Mods to get over bogging problem –early EVOs with Keihin Carb

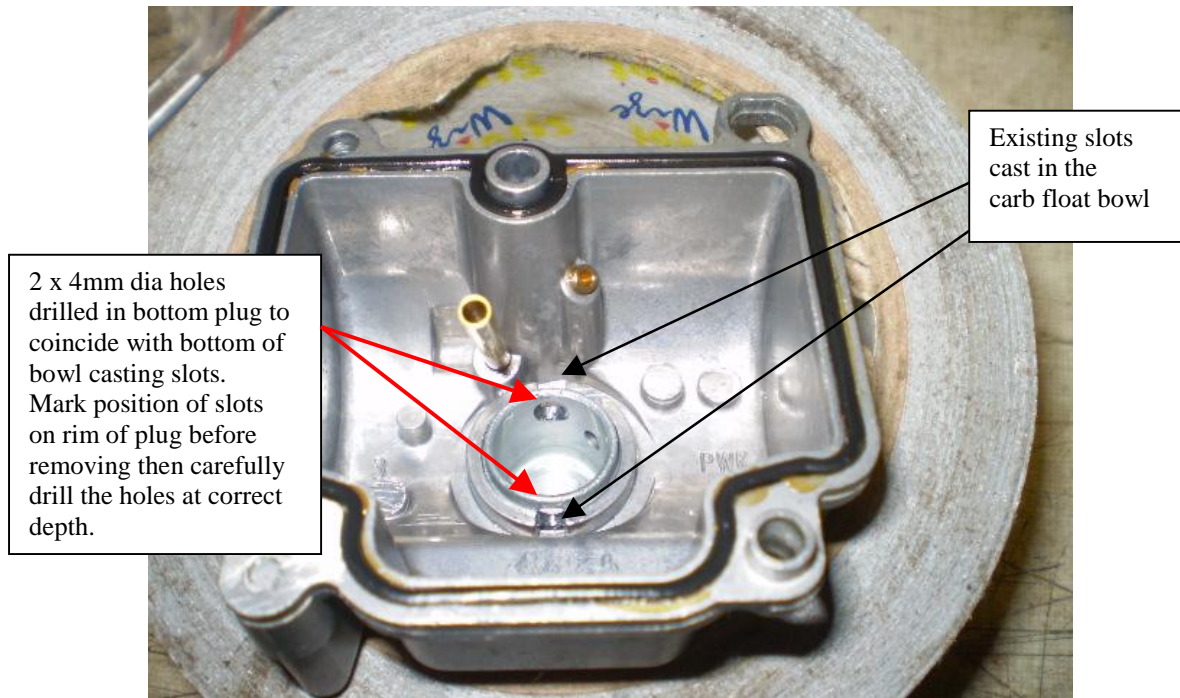
The first EVOs sometimes bogged going down hill or when hopping around. Originally it was thought that fuel was not flowing freely to the main jet when bouncing around, and the extra holes were drilled in the drain plug. The fix was mainly that the plastic overflow/vent pipe was causing siphoning. If this was route upwards somewhere above the carb the fault disappeared. In 2010 the pipe had a small vee cut in it to allow venting and the problem disappeared.

Drill holes in carburettor drain plug to allow full flow to jets (Griffo mod).

Make a mark like a saw cut on the outside of the float bowl and bottom plug to give correct alignment after plug removable.
